Stage 1/2 Road Safety Audit

Templar Place SHD, High Street, Balbriggan, Co. Dublin

Client:	Rhonellen Developments Ltd.
Document No:	201_321-ORS-XX-XX-RP-7d-001
Date:	19/07/2021

Figure 2.1 – Proposed Site Layout (Source: McCauley Daye O'Connell)

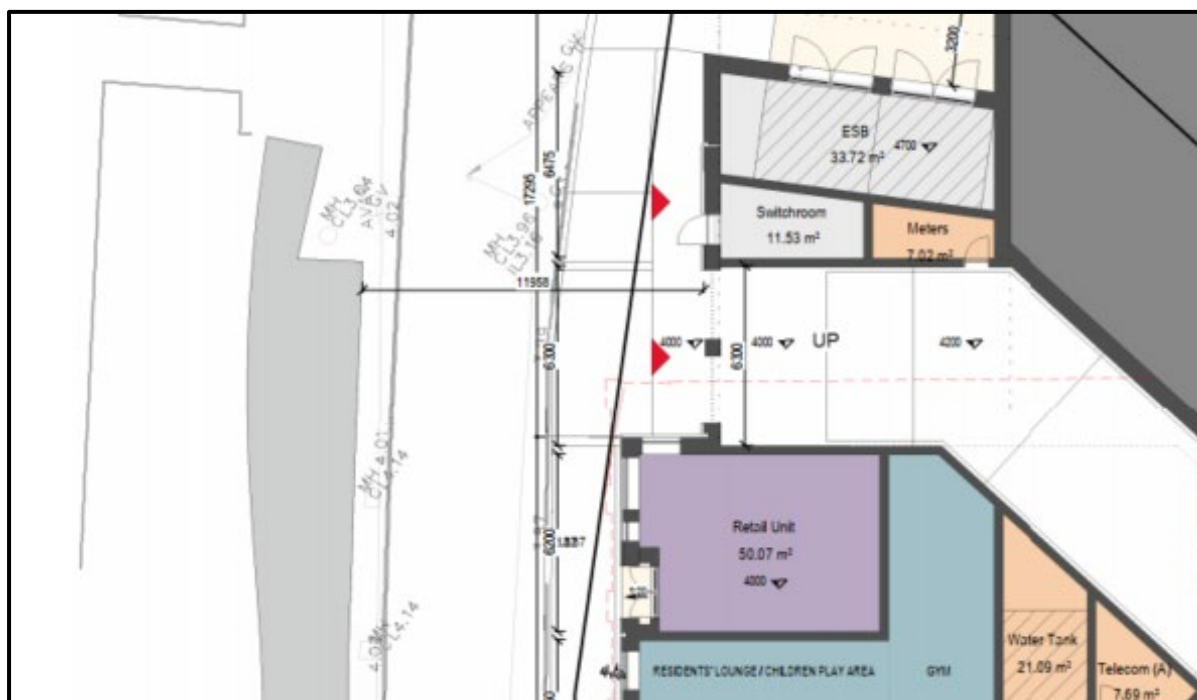
Location: Entrance to the Car Park Off Quay Street

The audit team note that the plans provided for the audit do not demonstrate the proposed security arrangement for the car park and if barriers or gates will be provided at the entrance. It is not clear if vehicles will be able to safely exit off the public street and wait if a barrier or gate is down. There is a potential serious safety risk if vehicles have to wait on the public road or are not fully off the carriageway resulting in possible rear end or shunt type incidents.

Location: Entrance to Car Park off Quay Street

The audit team note that Quay Street is a one-way only street at the proposed access point. The audit team are concerned that there is no information provided that informs the motorist

that they have to turn right out of the car park when exiting. There is a risk of motorists turning left onto oncoming traffic if sufficient information is not provided.

Location: Approaching Car Park Entrance on Quay Street

The audit team note that vehicles have to drive onto the footpath to view oncoming vehicles on Quay Street when exiting the car park. The sightline is further restricted due to the building footprint at this location. There is a risk that pedestrians may not notice the entrance to the car park until they are right at the point vehicles exit due to the car park being positioned behind the main building line on Quay Street. There is a potential risk of pedestrians colliding with vehicles causing injury.

Location: Approaching Car Park Entrance on Quay Street

The audit team note that vehicles currently can park along Quay Street in the vicinity of the proposed car park entrance. It is unclear if parking will be prohibited along this area on the proposed plans. There is a risk for vehicles exiting the car park if they cannot see oncoming vehicles on Quay Street due to the presence of parked vehicles.

Location: Entrance to Car Park off Quay Street

The audit team note from the drawings provided that there was no Auto Track analysis carried out on the internal road network. Inadequate road widths or turning radii may lead to the potential for pedestrian/vehicle collisions to occur. There could potentially be an increase in the number of sideswipes, side impact or rear end shunt type vehicle collisions. This poses a significant risk of injury to pedestrians and vehicle occupants.

It is recommended that the design team consider the security arrangements for the car park and ensure that all vehicles can safely approach a barrier or gate system that will not put them and other public road and pedestrians at risk. The designers should indicate on their plans the location of barriers and or gates to ensure they can be accommodated.

It is recommended that the design team consider providing signage and road markings to indicate that vehicles have to turn right out of the car park when exiting.

It is recommended that the design team consider providing signage and a barrier, bollard or guardrail at a suitable height before pedestrians have to cross the car park entrance to ensure that pedestrians are fully aware of the location of the entrance to the car park.

It is recommended that the design team consider removing parking spaces along the building frontage on Quay Street to ensure sightline requirements for the site access can be maintained as intended.

It is recommended that the design team carry out an *Auto Track* analysis on the internal road network to ensure all vehicle types can manoeuvre the site in a safe and efficient manner.

Problem Reference in Safety Audit Report	To Be Completed by the Designer			To Be Completed Audit Team Leader
	Problem Accepted (Yes/No)	Recommendation Accepted (Yes/No)	Alternative Option (Describe) (Only complete if recommendation not accepted)	Alternative Option Accepted by Auditors (Yes/No)
P1	Yes	Yes. A proposed security gate is to be provided and set back appropriately to allow vehicles to safely approach the gate without having to wait on the road and/or footpath.		
P2	Yes	Yes. Appropriate no left turn signage to be provided at exit.		
P3	Yes	Yes. Signage will be provided for pedestrians in advance of the carpark access.		
P4	Yes	Yes. Existing car parking spaces to be amended in consultation with the Local Authority to facilitate the car park access.		
P5	Yes	Yes. Autotrack analysis carried out on scheme with drawings provided.
